**CITY OF ISSAQUAH
DEVELOPMENT SERVICES DEPARTMENT
DEVELOPMENT COMMISSION**

STAFF REPORT

APPLICATIONS: Master Site Plan: MSP14-00002
Site Development Permit: SDP14-00001

PROJECT: **Issaquah Middle School**

Figure 4. Detail of Transportation Center Grading Plan showing location of the Category II wetlands buffer and building setback line as dashed lines. (Drawing not to scale)

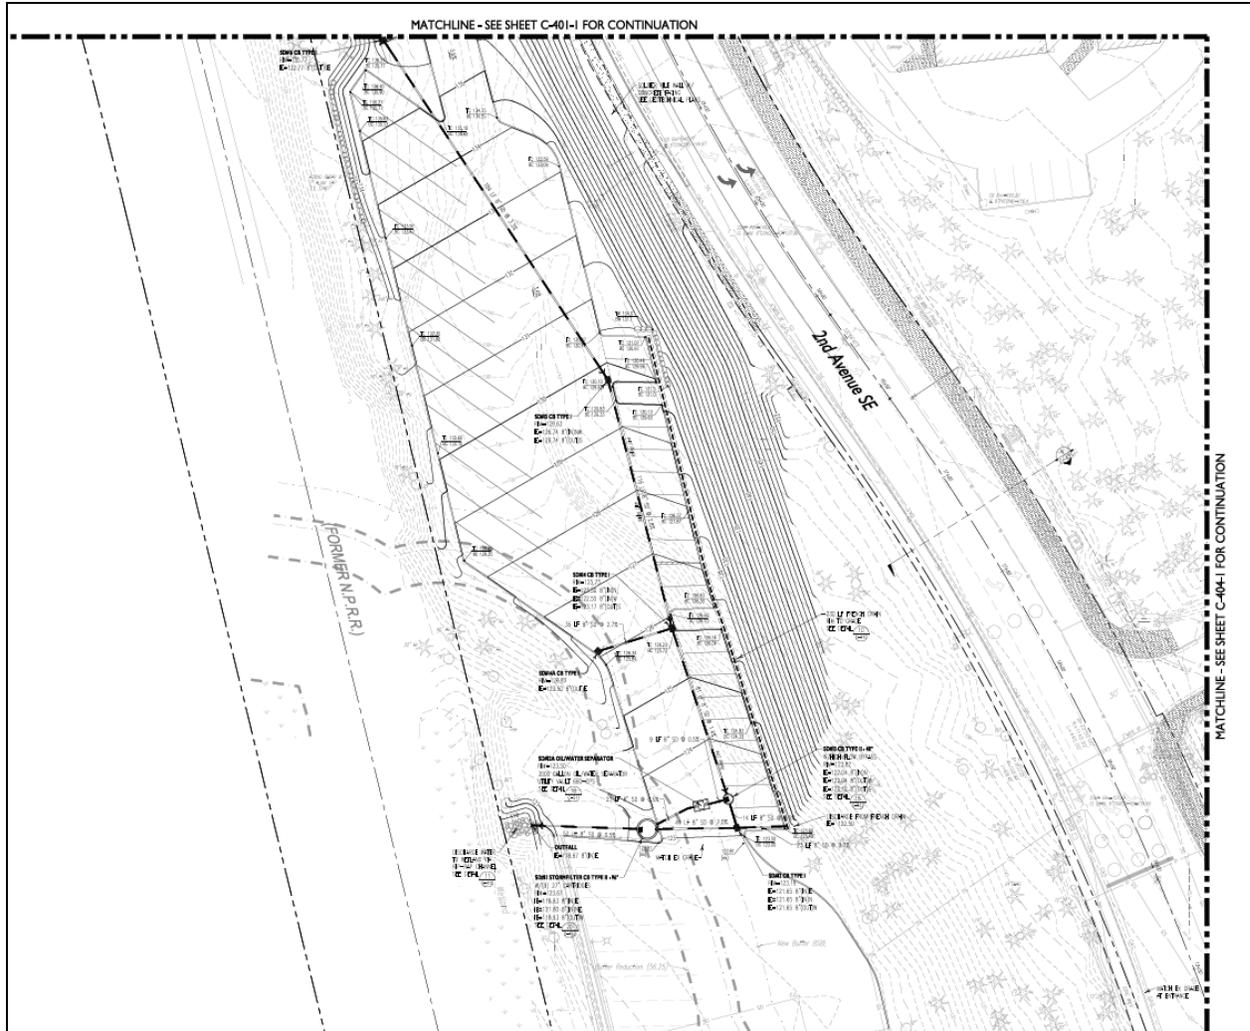
Wetlands: Two Category II wetlands (identified as Wetland A and Wetland B) are located at the western edge of the Transportation Center. The wetland requires a buffer of 75 feet plus a building setback of 15 feet from the edge of the buffer. The two Type II wetlands at the Transportation Center will not require mitigation because all grading work will be outside the buffers. Expansion of the transportation center's parking lot will need to comply with the regulations of the Critical Areas Regulations of the IMC, chapter 18.10. The wetlands and related buffers included in the Clearing and Grading Plans, Sheet C-402-1, is shown below.

There are two Category 2 wetlands along the western edge of the Transportation Center. A 75-foot buffer is required for Category 2 wetlands, according to IMC 18.10.640. Preliminary civil and landscape plans reviewed by the City show a 75-foot buffer in the Transportation Center with impervious surface outside of the buffer.

Figure 6. Pedestrian and School Bus conflicts.

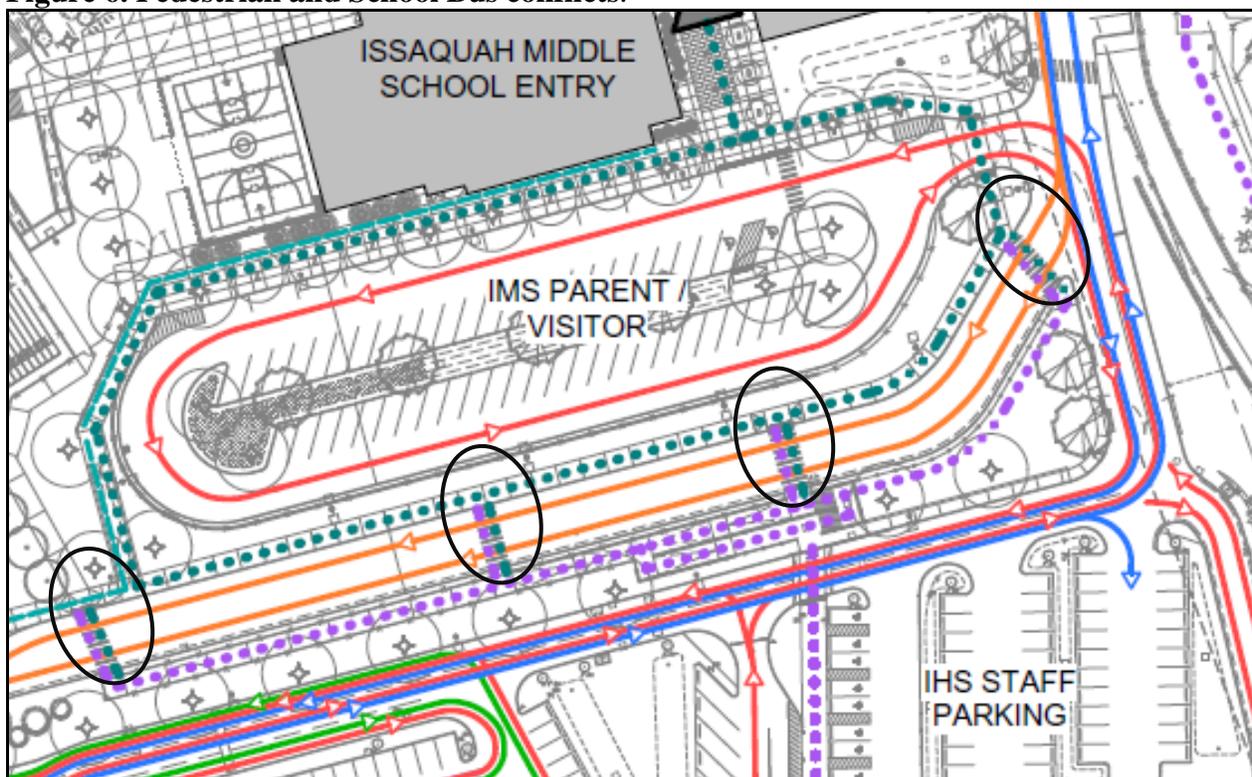
Student and pedestrian safety is compromised at the 4 crosswalks in the school bus drop off area (see areas circled in Figure 6, *Pedestrian and School Bus conflicts*, below). While having multiple accesses to the bus loading area from the new Middle School and the existing High School is a positive move, there are safety issues with mixing pedestrians and large vehicles in the same area. IMC 18.07.080.B (1)(c), *Crosswalks*, requires distinct paving for pedestrian crossings, excluding painting of road surface.

Conditions of Approval: See Condition D.1, D.3, D.10, D.11, D.12

Figure 7. Detail of the Site Accessibility Plan showing a future shared use trail connection to the existing Rainier Trail running along the 2nd Avenue SE frontage of the Middle School and crossing 2nd Avenue at the intersection of Evans Street.

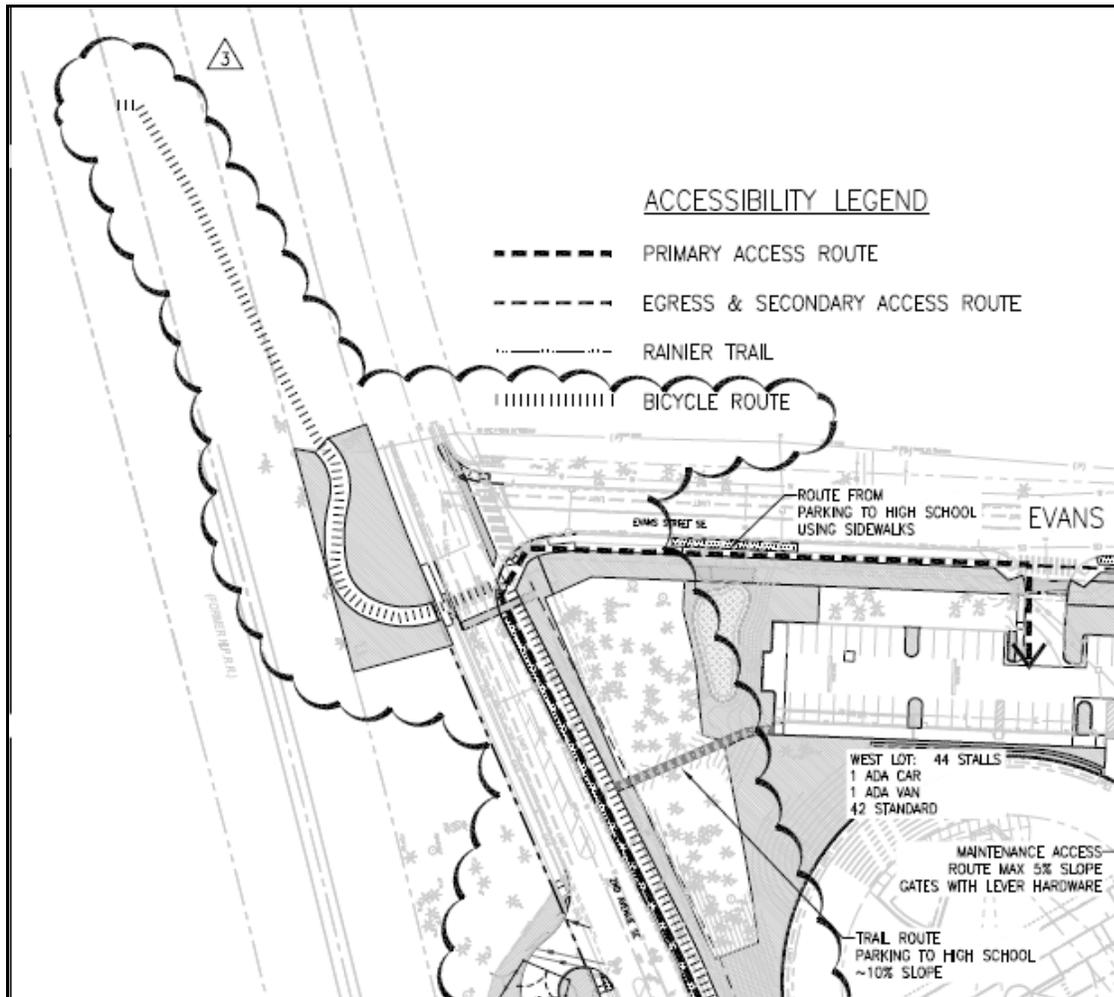
Rainier Trail affords an axial view of Mt. Rainier. The trail currently winds around the school site, forming a “U” along the perimeter of the School District property. The project will provide a 10-foot wide paved bike and pedestrian connection, or shared use route, from the school site to the western leg of the Rainier Trail. The final location of the trail has not been determined; however, building the

connection will require securing an easement from the private property owner east of 2nd Avenue SE to connect to the Rainier Trail.

Conditions of Approval: See Conditions D.7, D.8, D.9

Figure 11, Architectural elevation detail of the sliding metal panel door for the trash enclosure (Drawing not to scale)

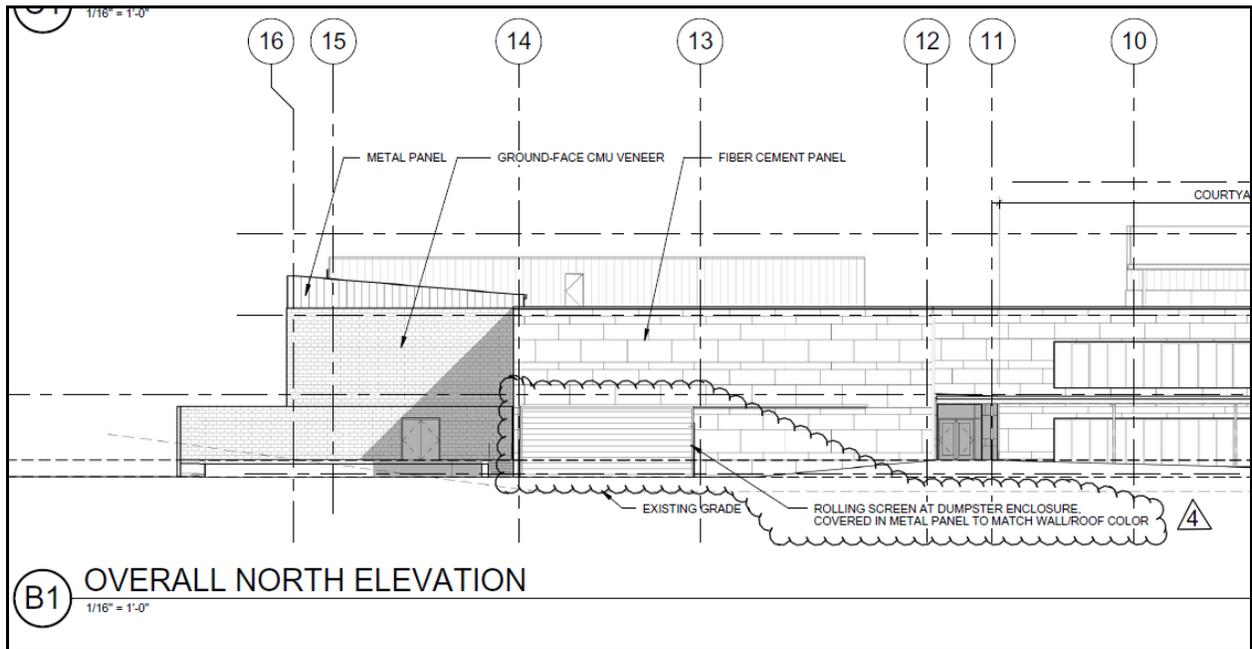
Findings of Fact: Location and number of waste and recycling receptacles are not provided at this time. A trash enclosure room is incorporated into the northeast corner of the school building adjacent to the service area. A sliding metal gate, similar in material and color to the roof clerestory and mechanical screen, will ensure that this area is screened from view along Evans Street. Further review by the City and their waste purveyor will be part of construction permit review.

Figure 14. Service Area. The site cross-section through the loading dock shows how the elevation change screens the cars in the parking lot from view along Evans. (Drawing not to scale, from Sheet LP-102)

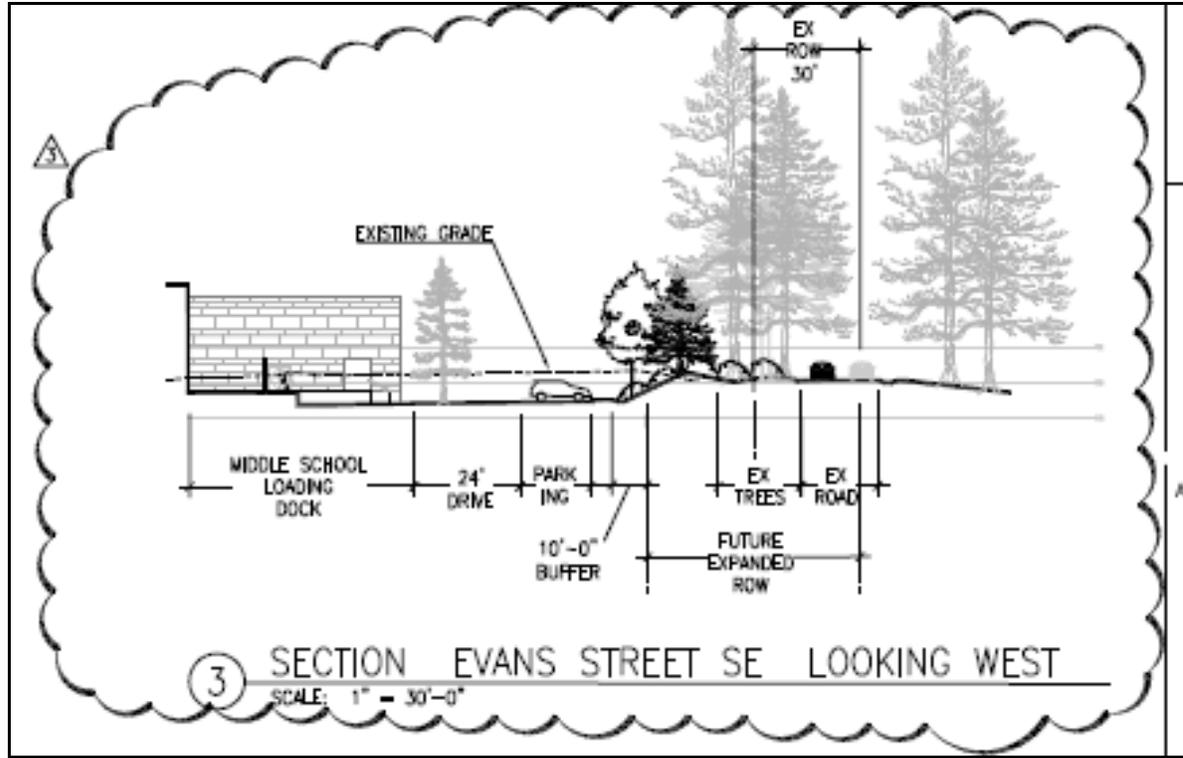
The landscape scheme generally shows that the parking lots are adequately broken up with perimeter landscaping and islands/peninsulas that can adequately support trees and shrubbery. Type 1 Landscape is provided along Evans Street to screen the parking areas and the loading area. The higher elevation of the Evans right-of-way also helps mitigate the visual impact of the parking lots and loading dock. Specific requirements for screening of the loading area and parking areas can be found under the Landscaping and Tree Retention section of this Staff Report. Additional staff analysis of loading and parking area site design are found in Appendix 2, Design Standards.

Conditions of Approval: See Conditions D.6, E.1

Figure 15. Cyclone fence between the north parking lot and courtyard entry

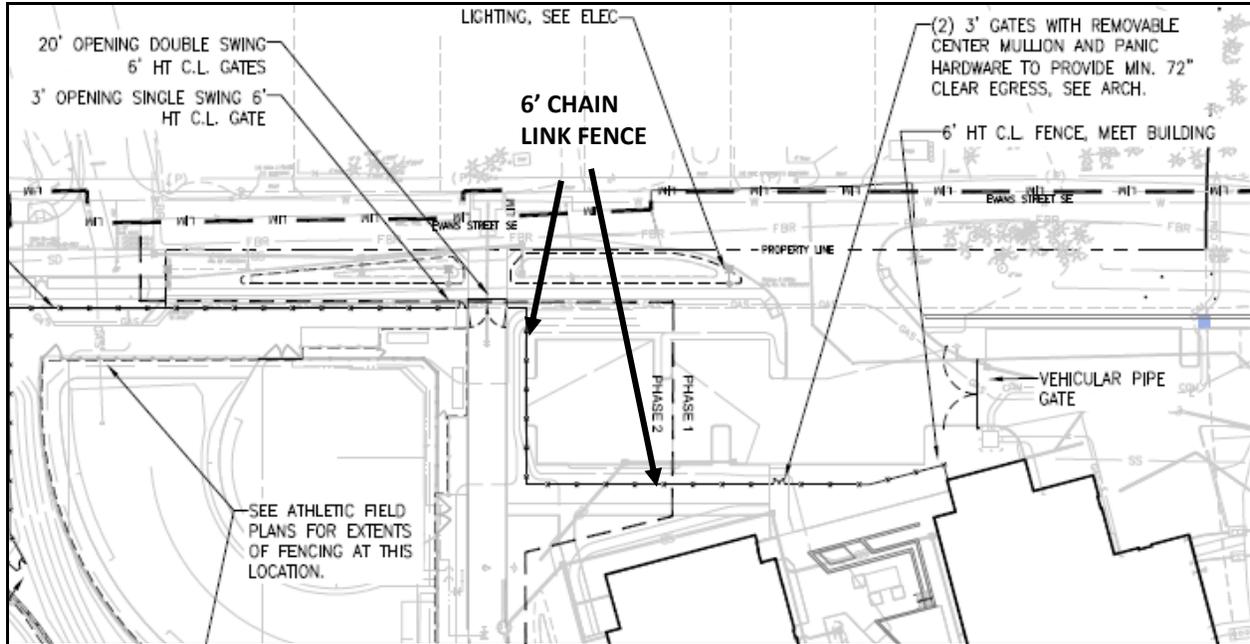
A 6-foot high chain link fence is also proposed along the north wall of the classroom wing and the north parking lot abutting Evans Street. This fence is meant to provide security for children and faculty in the school building and the courtyard.

Figure 16, Detail of plantings at courtyard cyclone fence

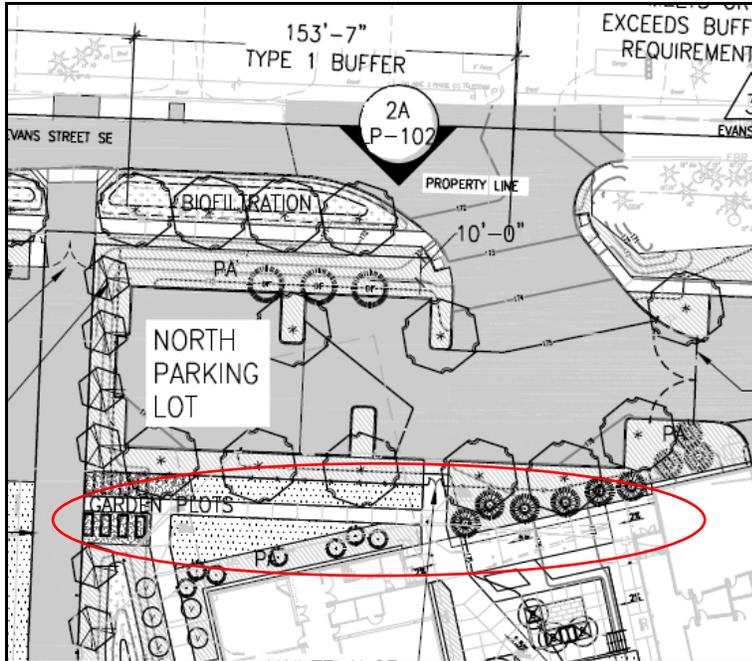
As depicted in the Landscape Plan detail below (Figure 16, Detail of plantings at courtyard cyclone fence), there are no landscape screening proposed for the chain link fence because the planting area is being used for parking lot trees.

Additional guidance on which side of the fence should be provided with landscape screening is found in IMC 18.12.130.A. Plantings are to be located along the side of the fence that has the greatest public use. A hedge along the south side of the fence may be as effective as a hedge along the parking lot side, given that the walkway provided leads to the garden plots. One thing to balance is the safety parking lot users by keeping clear sightlines from the school building to the parking lot and the need to mitigate the unattractive chain link fence. An ornamental fence may be the best solution to allow “eyes” on the parking lot while providing an aesthetically pleasing safety barrier for the school users.

A solid hedge along the south side of the chain link fence would serve the same purpose as one that is planted on the north side. Hedges eventually grow through chain link fences and can obscure the fence from both the neighboring uses, pedestrians on Evans Street, and the school occupants using the walkways to the garden plots and the courtyard.

Conditions of Approval: See Condition C.9
